Mobile Video Recorder

Version: V5.7.2 Release Note

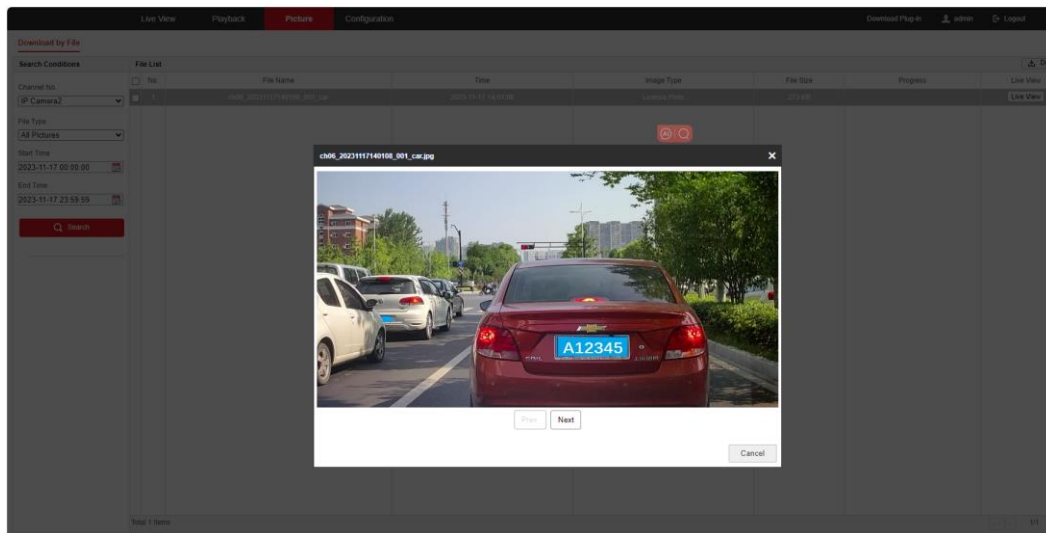
1. AE-MD5043/AE-MH0408 device newly supports BSD function. Currently, it supports ADAS (channel 1), DSM (channel 2), BSD (channel 3) ------ up to 2 algorithms can be run at the same time, and only DSM is enabled by default. , you can switch the algorithm at the position in the figure.

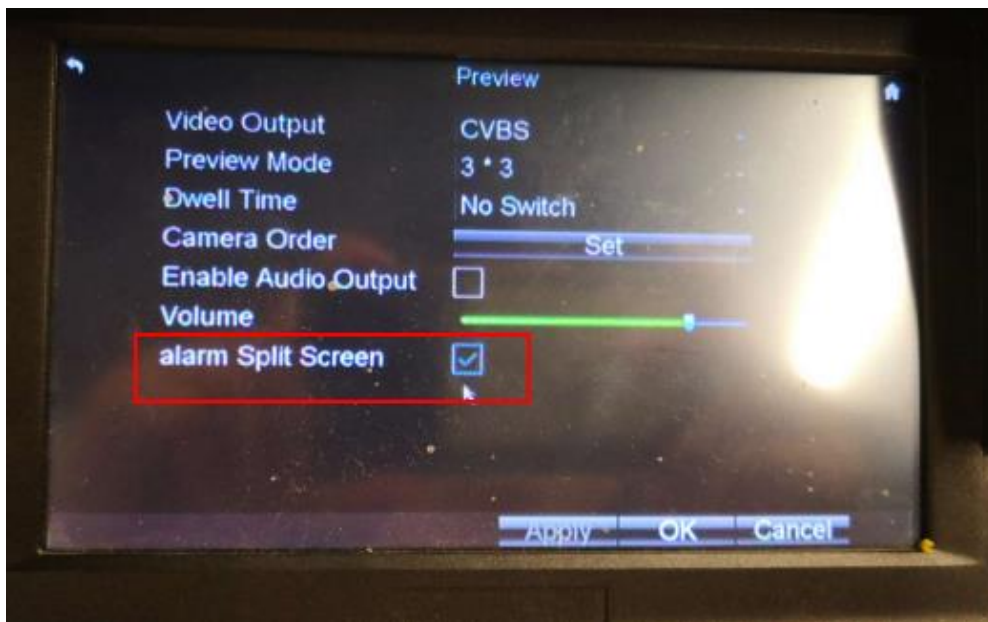
2. AE-MD5043-SD/I supports ADAS (channel 1), DSM (channel 2), BSD (channel 3), Three algorithms can be run simultaneously.

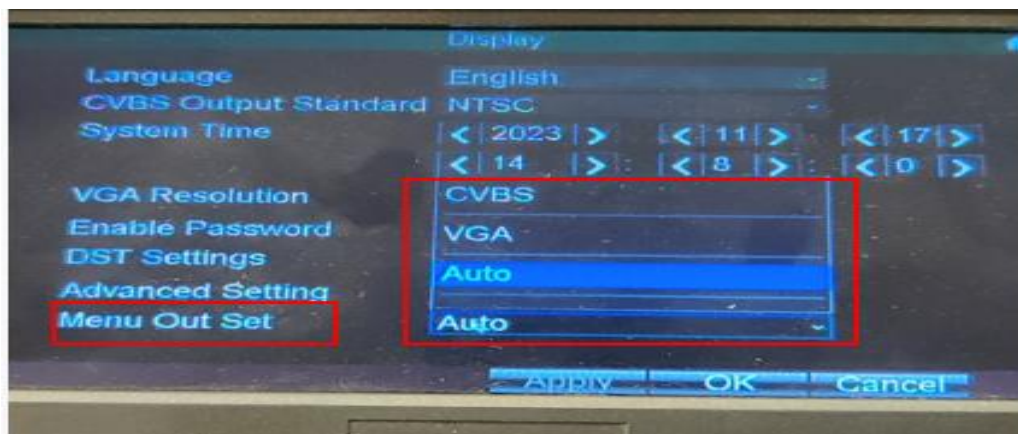
4. After connecting to the ANPR camera, it supports storing snapshots of the ANPR camera.
